**EVALUATION OF  
UNITED STATES GEOLOGICAL SURVEY  
GROUND-WATER FLOW MODELS  
OF COASTAL GEORGIA AND SOUTH CAROLINA**

**PROJECT REPORT 38**

Georgia Sound Science  
Initiative Review of  
Groundwater Flow Models

Georgia Sound Science  
Initiative Review of  
Groundwater Flow Models

**Figure 1**  
**Boundaries Of Regional Aquifer-System Analysis (RASA) Glynn County, Coastal, And Savannah Area Models**

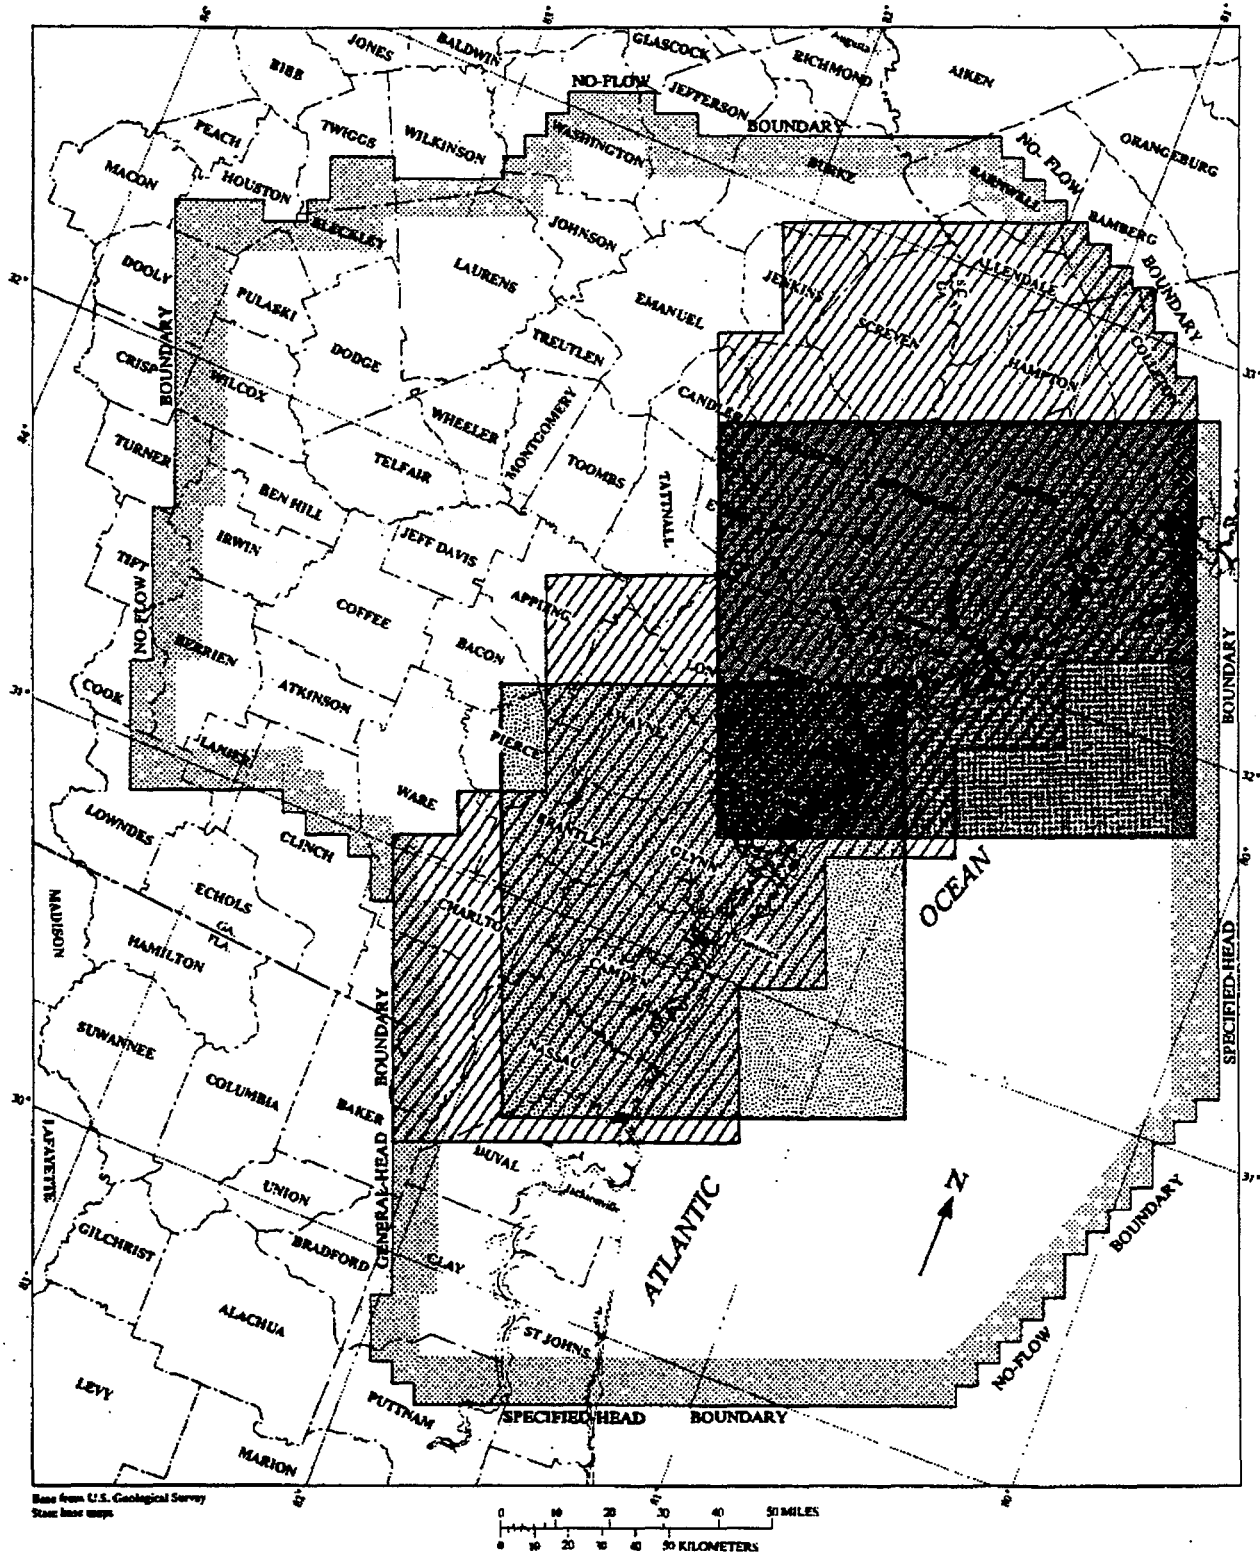
As shown in **Figure 1**, horizontal boundaries include an eastern offshore specified head boundary, an offshore no-flow boundary, a specified head boundary to the south, a general head boundary in the south west, a no-flow boundary in the north west, and a no-flow boundary in the north. The surface is a specified head boundary, and the bottom of the model is either a no-flow boundary, or a specified head boundary where the Fernandina exists.

The horizontal boundaries selected for the RASA model appear to be, for the most part, well thought out and properly defined. The USGS appears to have a good, hydrologic explanation for the no flow boundaries and for the western boundaries. The boundaries to the west are shielded by the Gulf Trough from

The specified head boundary in the northeastern part of both the RASA and Savannah model is quite close to the Hilton Head area and may be influencing the heads simulated at Hilton Head. According to existing data, a hydrologic boundary is close to Hilton Head because the aquifer pinches out, or the salt water boundary exists close to shore. The selection of a specified head boundary is used to represent this physical boundary. An examination of the response of indicator nodes in this area during our sensitivity testing illustrates the "damping" effect of this boundary (see Appendix A for the results matrix). It is possible that this boundary could result in a lack of response to pumping in both the RASA and Savannah models in this area. It is also troubling that this boundary was changed between the pre-development and post-development simulations. In updating the models, this boundary should be re-examined.

A second concern is the specified flux boundary to the south west. This boundary is the source of a significant amount of water to the model under present day conditions, and a no flow boundary under predevelopment conditions. The rationale for this is unclear. Although the boundary may be based on correct assumptions, the fact that the boundary was changed between the pre- and post-development simulations indicates that this boundary is important to the results and should be examined more closely. In updating the model, a better explanation of the hydrologic basis for this boundary should be provided, or the boundary should be changed to have less influence on the results near the coast.

Simulation: Base Case Undeveloped

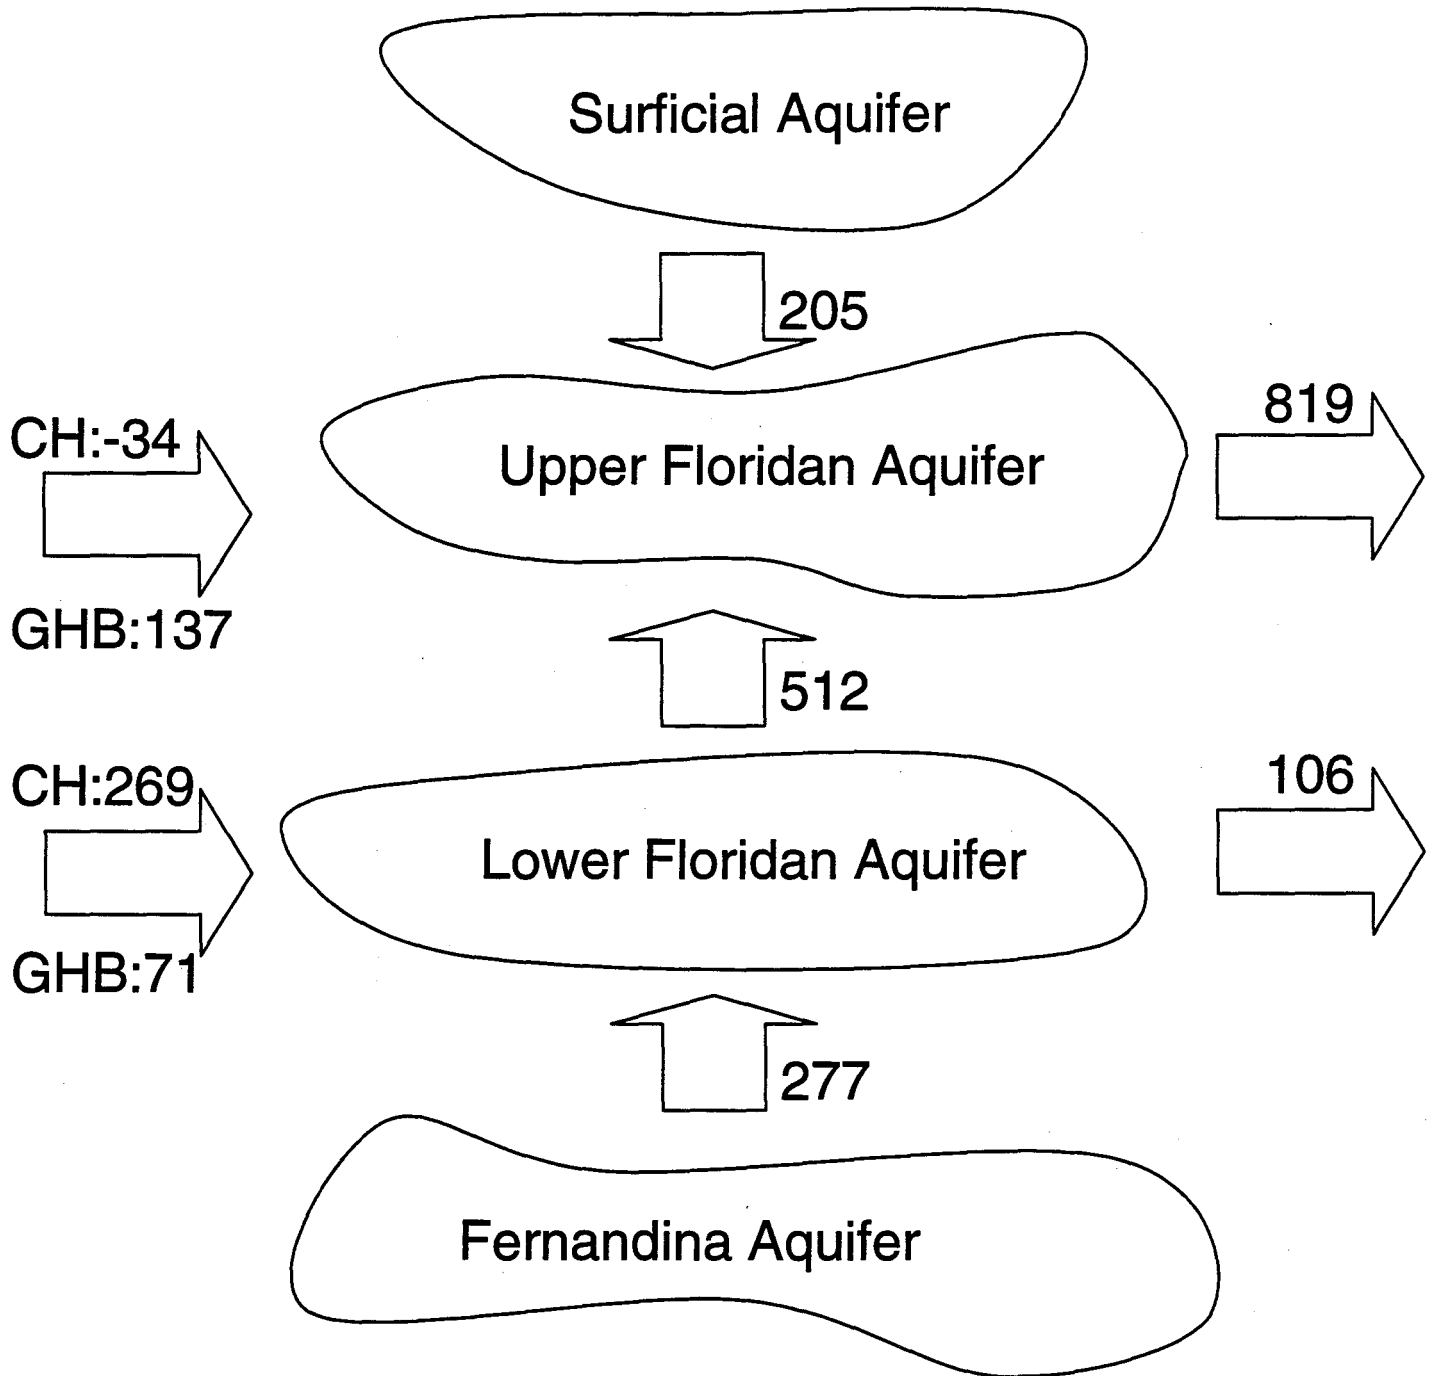
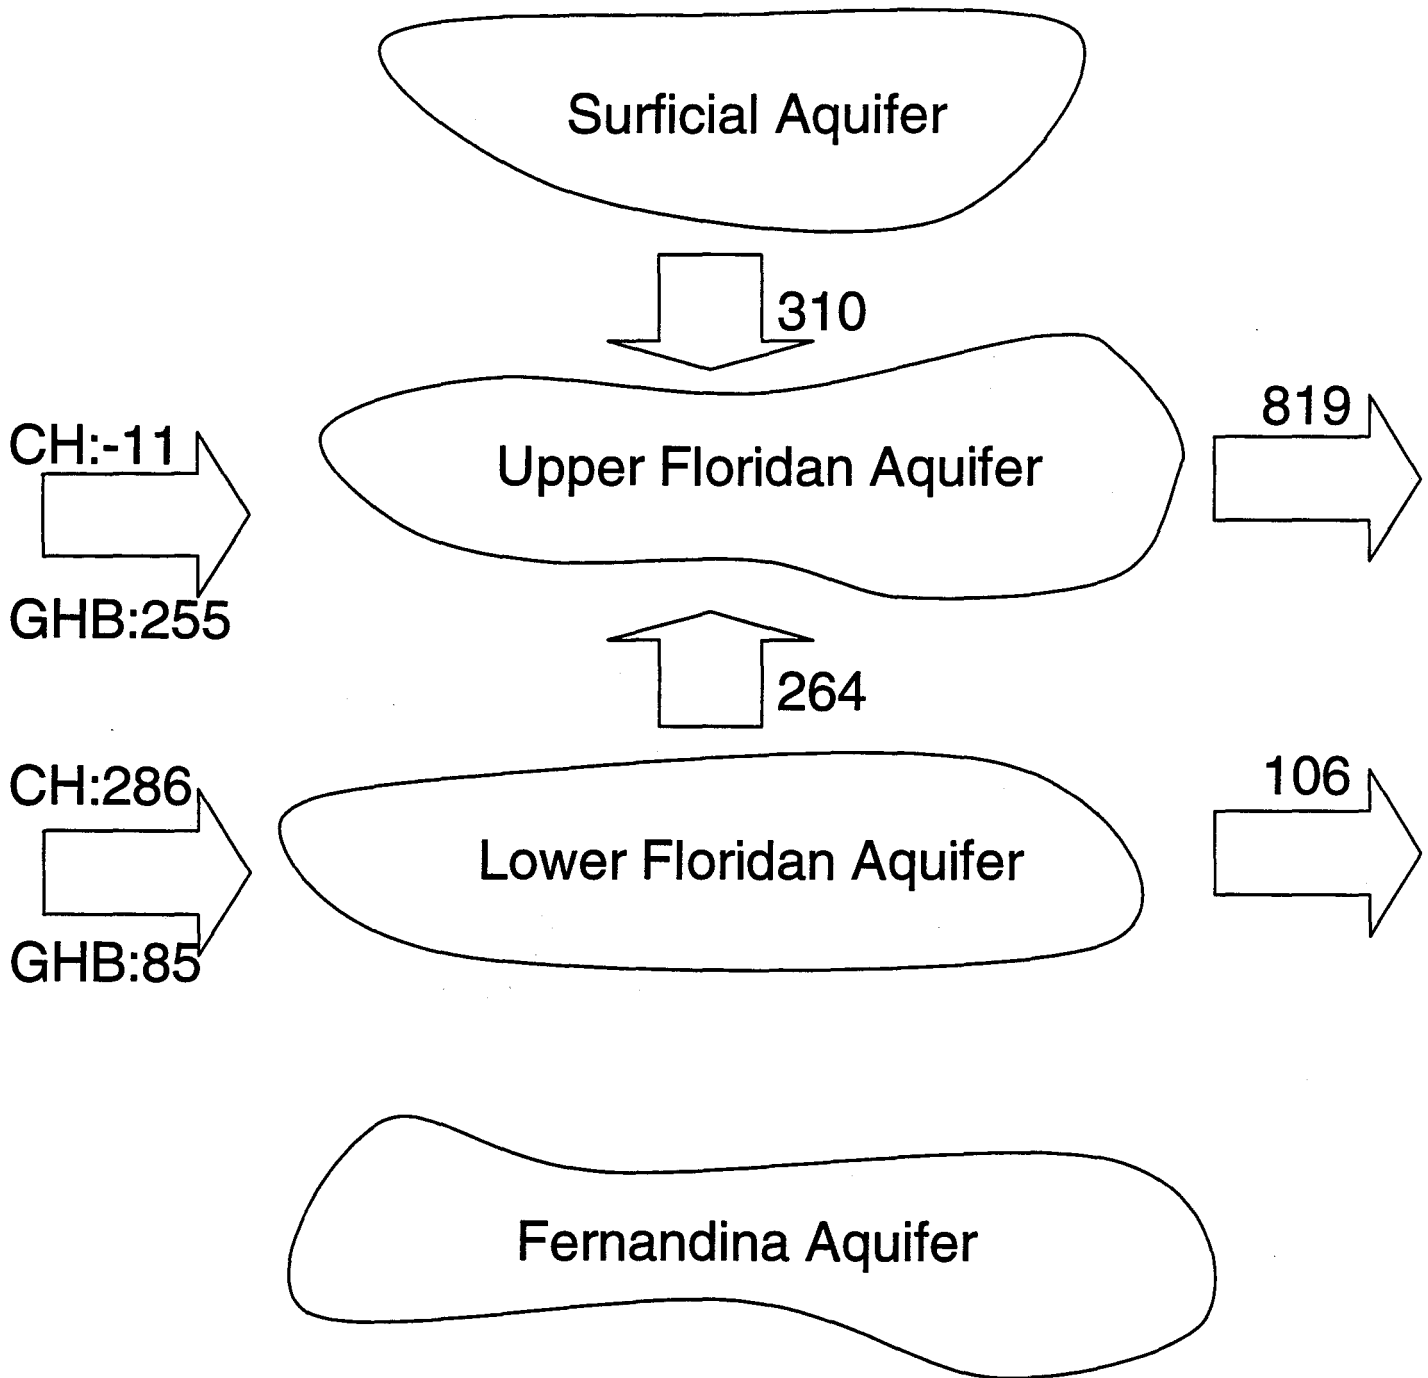
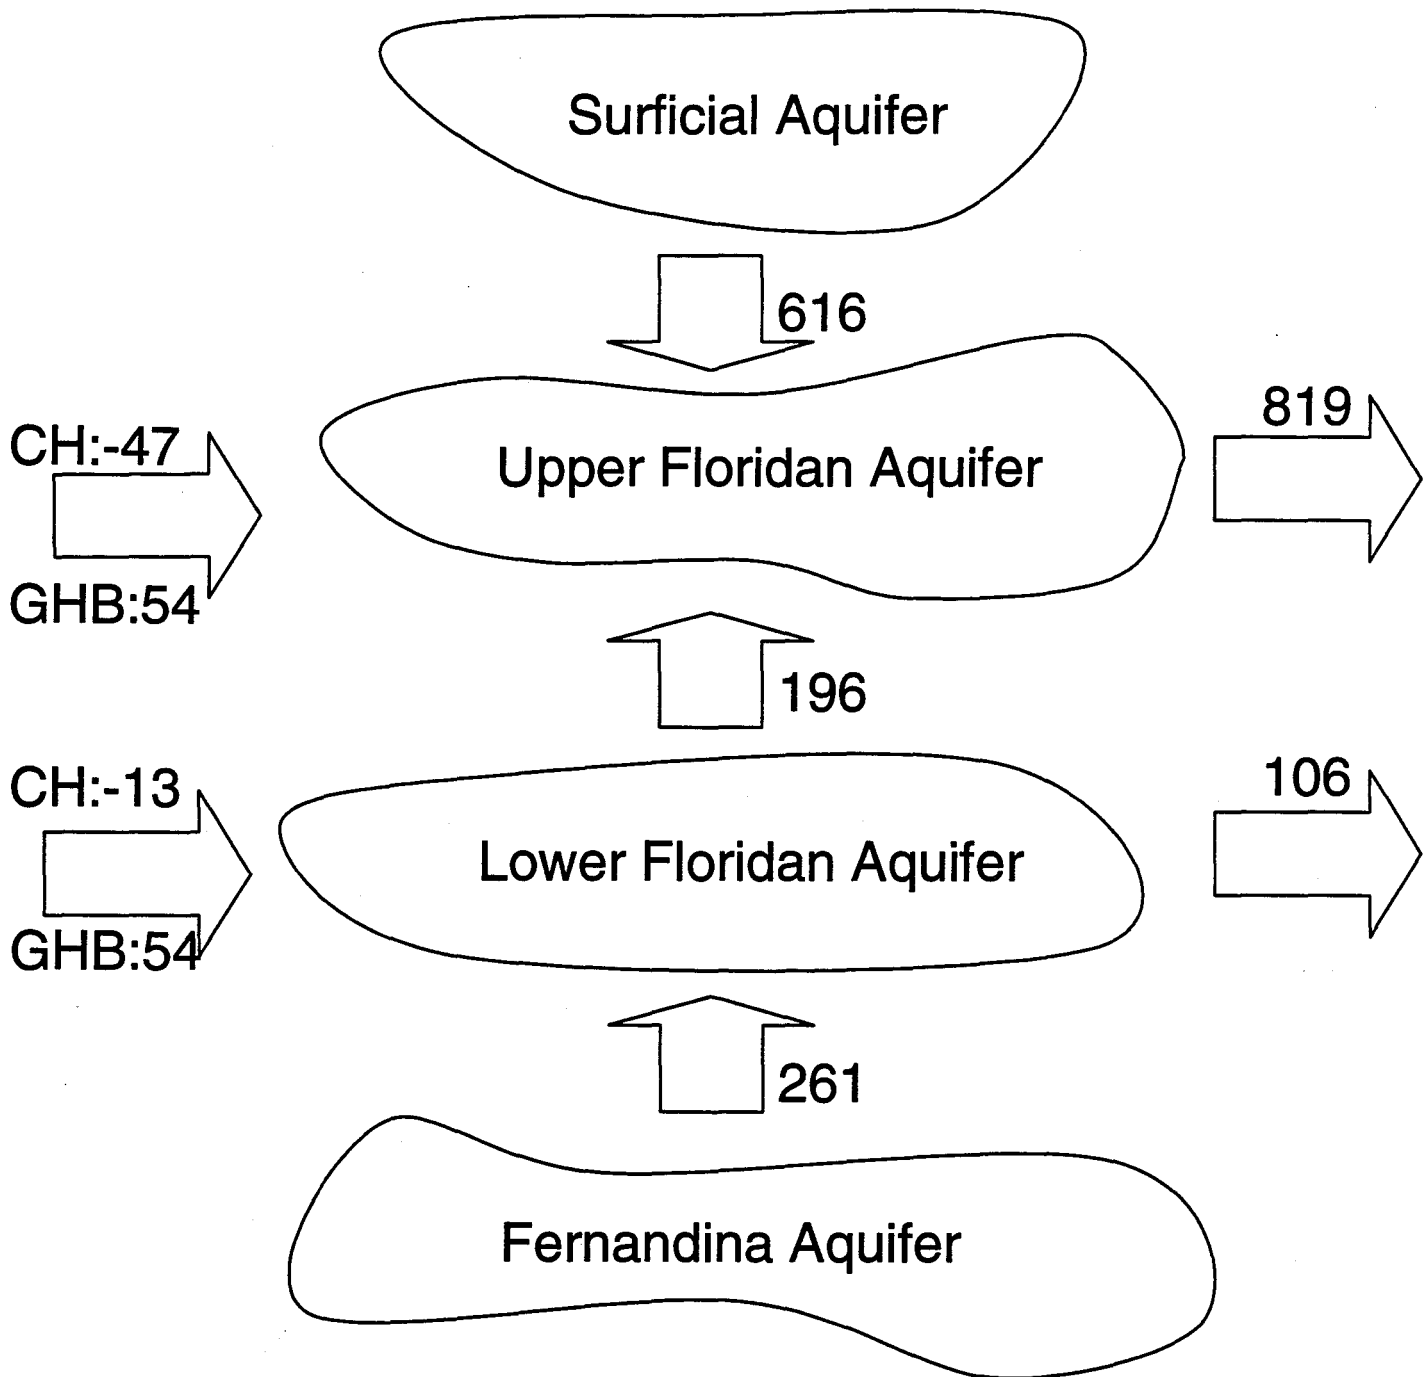
The two contrasting situations indicate that the model is sensitive to its boundaries, and that the balance of water inflow between the three potential sources is an important issue. Figures 6 and 7 illustrate this point further by making changes to the boundary assumptions. In figure 6, flows from the Fernandina are eliminated and the water balance changes significantly. Much

more water enters the model through the surficial aquifer and through the general head boundary to make up the loss of water from below. The same is true if the fixed heads are adjusted in the surficial aquifer (figure 7). In this case, the increased flows from the surficial aquifer, due to a 20 percent increase in assumed heads, are offset by reduced flows from the boundaries. Note that the model fluxes must balance within a simulation. Thus in the two sensitivity simulations shown in figures 6 and 7, in order to adjust the fluxes, the distribution of heads simulated in the model changed significantly and no longer matched the data. This usually indicates that the simulated fluxes could be accurate, however, additional investigation is needed to confirm this.

**Table 1**  
**Comparison of Savannah and Smith Models**

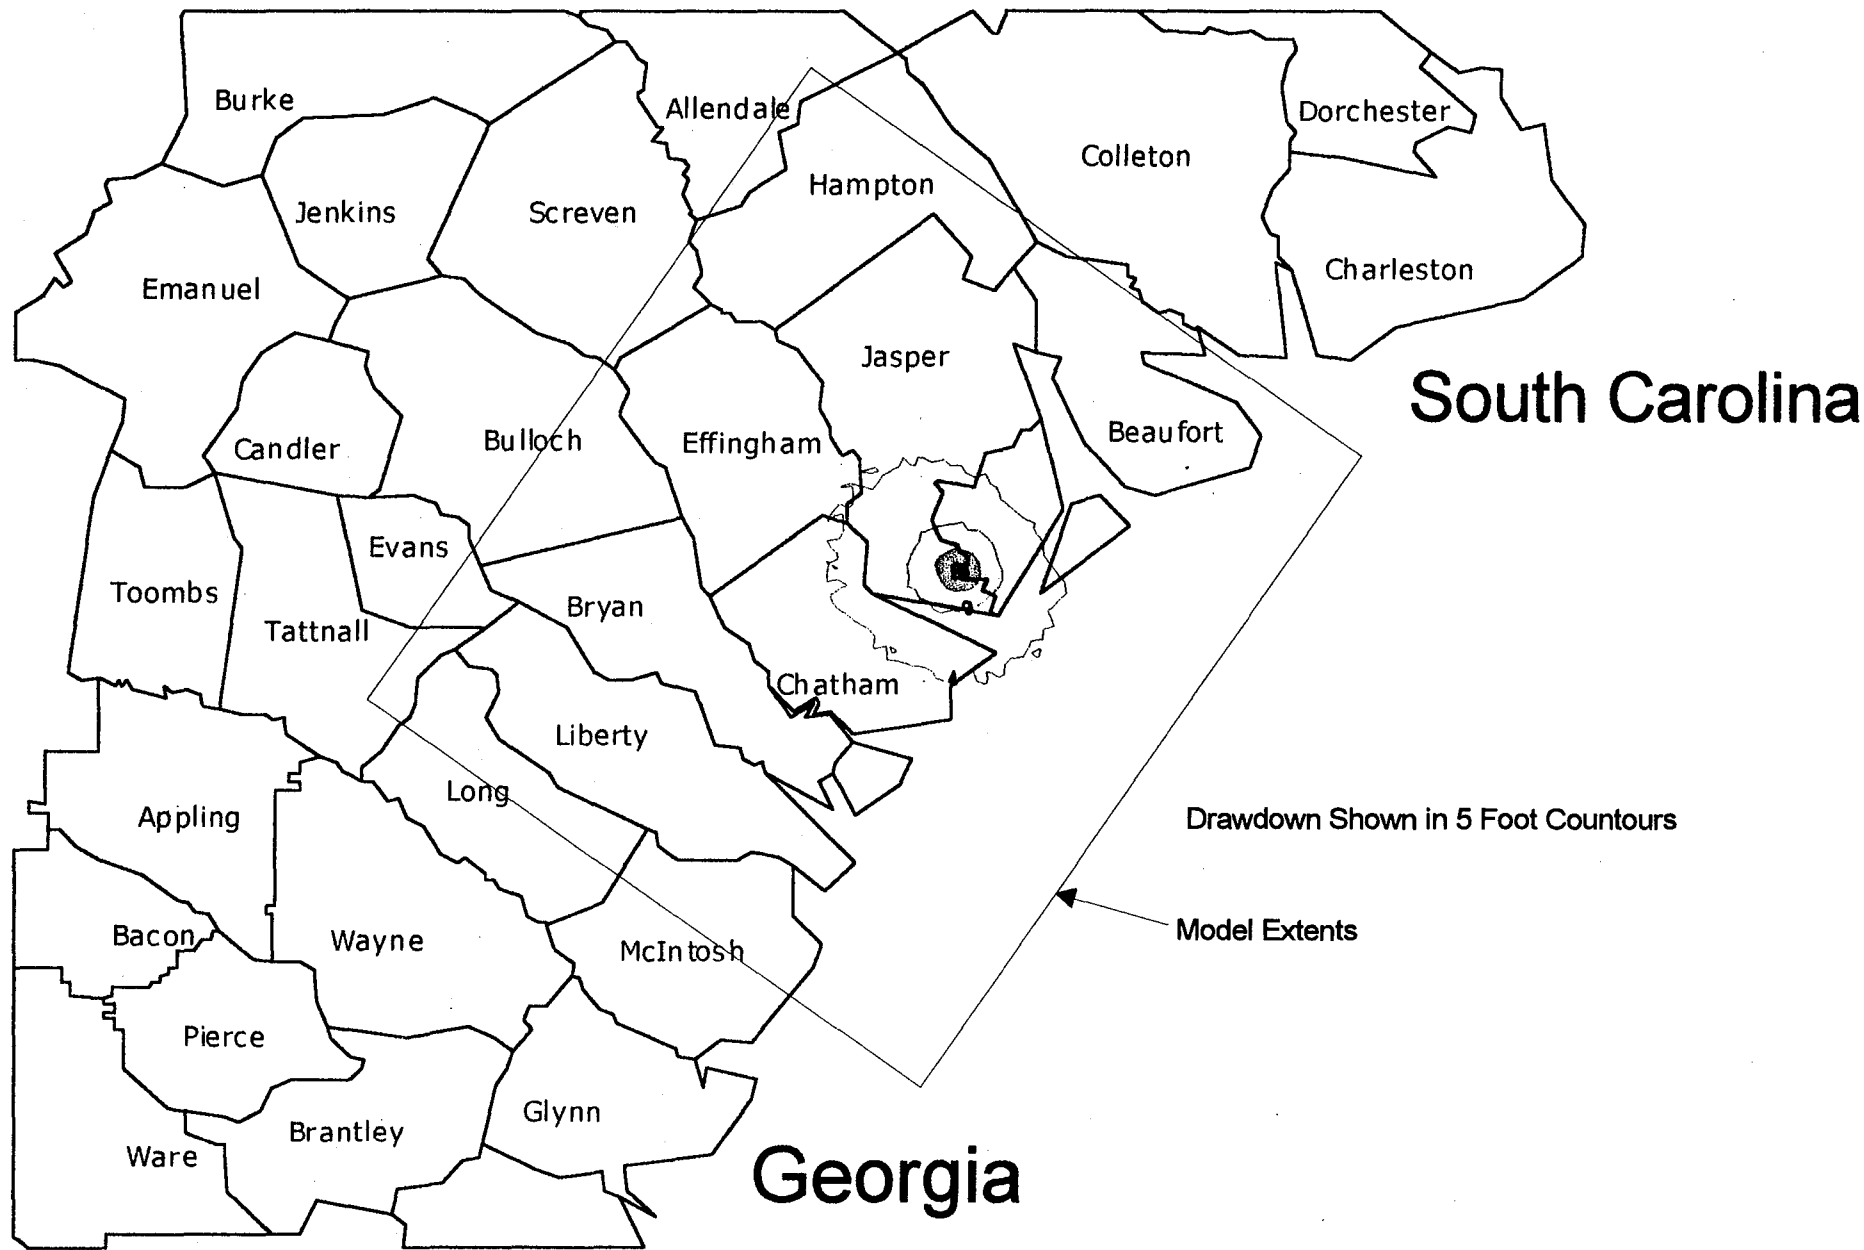
The assumptions underlying both models, however, result in different flux balances. This is illustrated in **Table 1**.

Because the Smith model assumes no flow between the lower and upper Floridan Aquifers and the Savannah model assumes fairly significant flows between these aquifers, the relative amounts of flow into and out of the model are different. This suggests that our understanding of fluxes is still incomplete, and future, updated models, must improve on this.
